TOWNSHIP OF VERONA BOARD OF ADJUSTMENT APPLICATION

BOARD OF ADJUSTMENT APPLICATION SITE PLAN

January 12, 2024

Re: Zoning Permit #2023-226

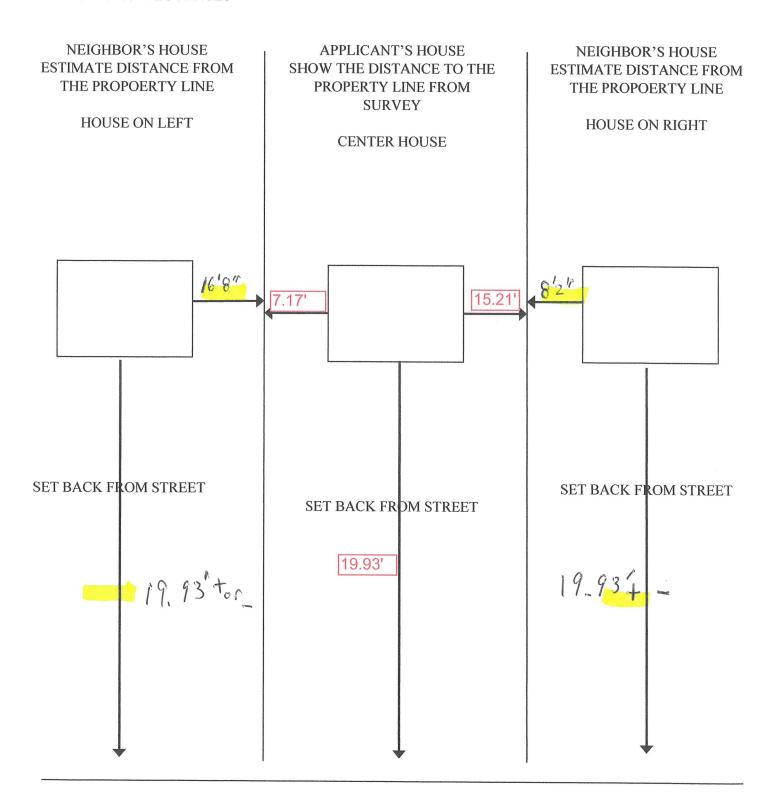
The lot coverage exceeds the maximum permitted lot coverage of 25%, as per section 150-17.4 D (3), with a proposed coverage of 31.37%. A variance is required.

The improved lot coverage exceeds the maximum permitted improved lot coverage of 40% as per Section 150-17.4 D (4), with a proposed coverage of 42.69%. A variance is required.

The proposed east side yard setback of 5 feet does not comply with the minimum 8 feet required per Section 150-17.4 E (2). A variance is required.

The proposed combined side yard setback of 12.17 feet is not compliant with the minimum 18 feet required as per Section 150-17.4 E (3). A variance is required.

The existing front yard setback of 19.93 feet is non-conforming to the required minimum front yard setback of 30 feet as per Section 150-17.4 E (1); however, it is permitted as per Section 150-13.3.

The existing west side yard of 7.17 feet is non-conforming to the minimum requirement of 8 feet as per Section 150-17.4 E (2); however, it is permitted as per Section 150-13.3.

The proposed 47.15-foot rear yard setback complies with the minimum requirement of 30 feet as per Section 150-17.4 E (5).

The proposed addition height of approx. 24. 6 feet is compliant with the maximum permitted height of 30 feet as per Section 150-17.4 E (6) but permitted as per Section 150-13.3.

The proposed patio complies with Section 150-5.3 C (6), which requires a 5-foot minimum setback from the property line. The proposed setback is 5 feet.

Stormwater management is exempt since there is a decrease in impervious coverage.

As noted on the plan, no trees are proposed for removal.

As per Section 150-7.12 A of the Zoning Code, the height of the wall cannot exceed four (4) feet in the front yard and six (6) feet elsewhere. The proposed walls have a height varying from 3.2 feet to 4 feet. Therefore, the applicant's request for zoning approval for the wall has been <u>APPROVED</u> by this office. An <u>Engineering Review and Approval</u> will be required. A \$750 fee and W-9 form is required to open an escrow account. Please contact our office if you have any questions. Retaining walls four (4) feet in height from the bottom of the footing to the top of the wall will require a construction permit.
